## **BCA ASSESSMENT REPORT**

**OAKDALE SOUTH ESTATE  
SITE 3A - SIGMA  
MILNER AVENUE, HORSLEY PARK**

**PREPARED FOR:  
GOODMAN PROPERTY SERVICES (AUST) PTY LTD**

Revision 4

#### **8. Clause C2.4 – Requirements for Open Spaces & Vehicular Access**

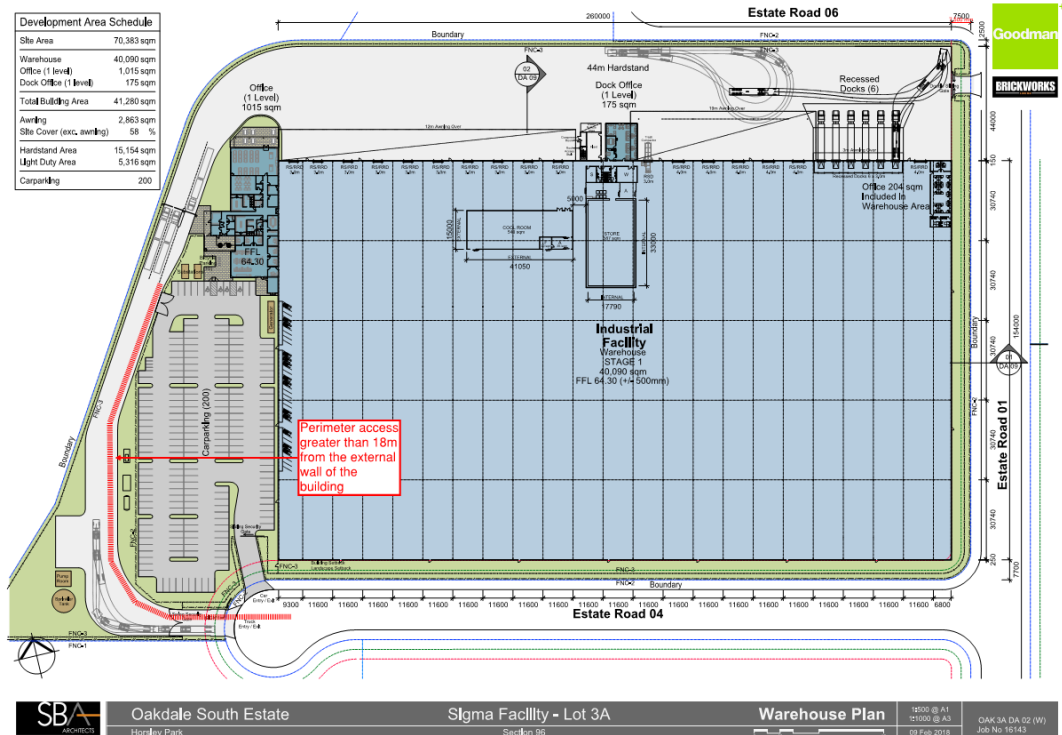
*Comments:* It will be necessary for an alternative solution to be prepared to address these non-compliance issues below, in order to demonstrate compliance with Performance Requirement CP9. The departures from this clause are as follows:

- + The vehicle access in the SW corner and western side of the building is greater than 18m from the building as identified below.
